Range Road 231/232 Functional Planning Study Survey – October 2018

Strathcona County Online Opinion Panel feedback

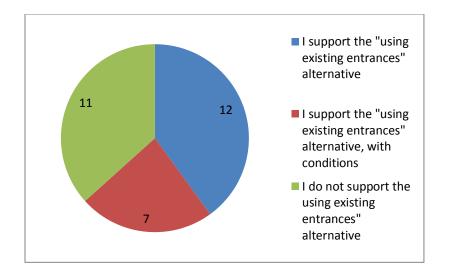
- 1. Do you have any feedback on the two alternatives above? If so, please use the text box below the image to share your feedback.
- If you use roundabouts, please don't plant vegetation in the middle as it reduces sight lines throughout the circle.

- I feel roundabouts would keep traffic flowing better, but should only be added when the traffic volume gets high enough at each intersection.
- I prefer the roundabouts if they are large enough to accommodate large trailers and rvs.

- it makes more sense to me to install lights at both of these RR'ds at the 522 Twnp roads, than any roundabouts
- Prefer roundabouts
- I guess I prefer roundabouts in areas where traffic is not heavy

- prefer roundabout to traffic lights
- Roundabouts the preferred option
- Roundabouts all the way
- No to signals
- Roundabouts preferred for the roads in the study area.

- I much prefer roundabouts because they maintain better flow of traffic and are better for the environment (less complete stops), but they still slow traffic down and allow for the safest points of entry from side streets.

- My preference is signals.
- Prefer roundabouts
- The traffic circles are preferred over lights. The stop signs are working now though.
- No one knows how to properly use the current roundabout we have in Sherwood park. Adding more roundabouts would not be a positive change in my opinion.
